Product change notification

DRW

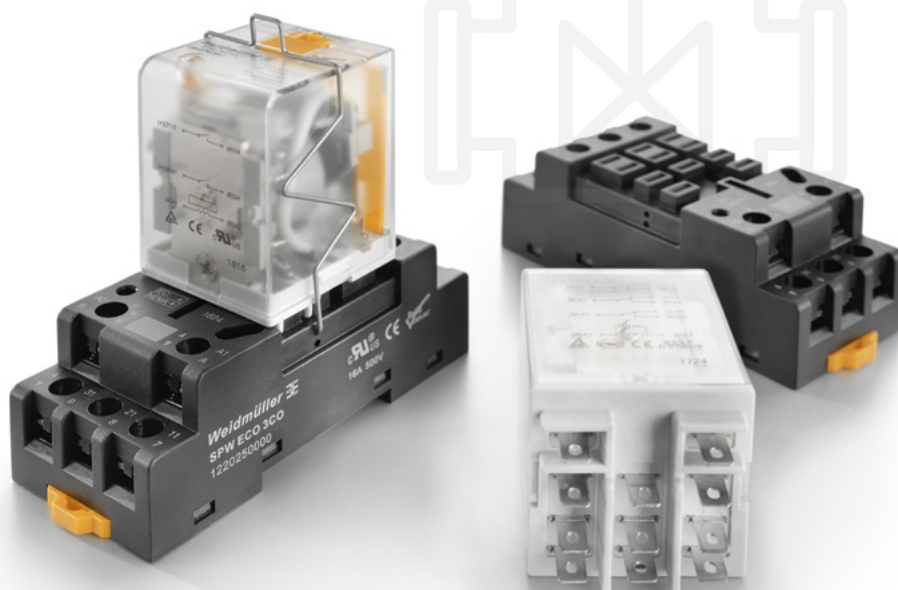
This article uses an exemption named in Annex III of the RoHS Directive 2011/65/EU "8b - Cadmium and cadmium compounds in electrical contacts", which could only be valid until 21.07.2021, depending on the product category. Please check whether you can use this article depending on the place of marketing and the product category concerned

Industrial power relays of our D-SERIES DRW have a width of 39 mm and are equipped with wear-resistant contact material and a large contact opening. The product quality stays the same with the new contact material AgSnO2.

new version

Type	Contact material	Order No.
DRW273012LT	AgSnO2	2765590000
DRW273024LT	AgSnO2	2765600000
DRW273048LT	AgSnO2	2765610000
DRW273110LT	AgSnO2	2765620000
DRW273220LT	AgSnO2	2765630000
DRW273524LT	AgSnO2	2765490000
DRW273548LT	AgSnO2	2765500000
DRW273615LT	AgSnO2	2765510000
DRW273730LT	AgSnO2	2765520000
DRW273900LT	AgSnO2	2765530000
DRW373012LT	AgSnO2	2765640000
DRW373024LT	AgSnO2	2765650000
DRW373048LT	AgSnO2	2765660000
DRW373110LT	AgSnO2	2765670000
DRW373220LT	AgSnO2	2765680000
DRW373524LT	AgSnO2	2765540000
DRW373548LT	AgSnO2	2765550000
DRW373615LT	AgSnO2	2765560000
DRW373730LT	AgSnO2	2765570000
DRW373900LT	AgSnO2	2765580000
